National Transportation Safety Board

Safety Recommendation

Date: November 17, 2010

In reply refer to: A-10-132 through -135

Figure 2. Apical emergency float system port fitting and hose connections to forward, mid, and aft floats.

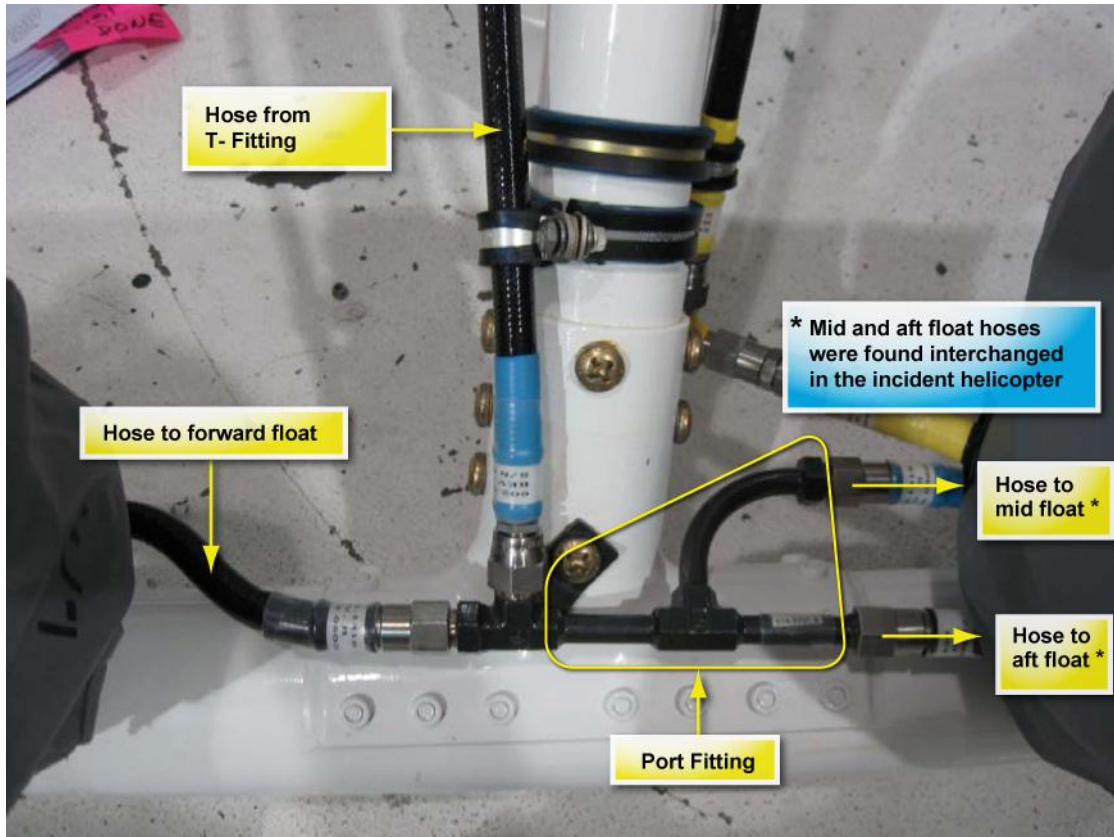
As noted, examination of the incident helicopter revealed that the hoses for the mid and aft floats were interchanged, allowing nonrestricted gas flow to the mid float. This mistake is possible because both hoses can connect to either hose connection at the port fitting. According to Apical, if these hoses are interchanged and installed incorrectly to the port fitting, the gas will not distribute properly through the port fitting and the mid float will inflate quicker than the aft float. This error will result in increased pressure beyond the mid float's designed capacity, which can lead to bursting, and reduced pressure and insufficient gas flow to the aft float. This uneven gas distribution can lead to the risk of inversion because the floats will not inflate uniformly.

Based on the similar design and size of the connections of the float hoses to the port fitting and given repetitive findings by PHI and other operators, the NTSB concludes that the hoses that connect the mid and aft float to the port fitting can easily be interchanged and installed incorrectly, resulting in low inflation pressure in the aft float with simultaneous excessive pressure in, and rupture of, the mid float. The NTSB further concludes that a new design is needed to ensure that the required hoses will, in every instance, be connected only to their proper fittings. Such a design could use different sizes of hose-to-port fittings or different design connections so that a float's hose can only be connected to the proper opening at the port fitting and cannot be interchanged. Therefore, the NTSB recommends that the Federal Aviation Administration (FAA) require Apical Industries Inc., to redesign the emergency float system for helicopters such that the hoses for the mid and aft floats can no longer be interchanged and installed incorrectly to the port fitting. Once the redesigned emergency float system described in Safety Recommendation A-10-132 is available, the NTSB recommends that the FAA require operators of all helicopters currently equipped with Apical emergency float systems to install the redesigned system.

Require Apical Industries Inc., to redesign the emergency float system for helicopters such that the mid and aft floats can no longer be interchanged and installed incorrectly to the port fitting. (A-10-132)

Require operators of helicopters equipped with Apical emergency float systems to immediately conduct a one-time, two-person, visual inspection to ensure that the hoses from the mid and aft floats are properly installed to the port fitting. (A-10-134)

Until the redesigned Apical emergency float system is installed as described in Safety Recommendation A-10-133, at every maintenance activity that requires disconnection of the hoses, require a two-person inspection of the re-installation of the hoses from the mid and aft floats to the port fitting and to sign a maintenance checklist attesting to proper installation. (A-10-135)
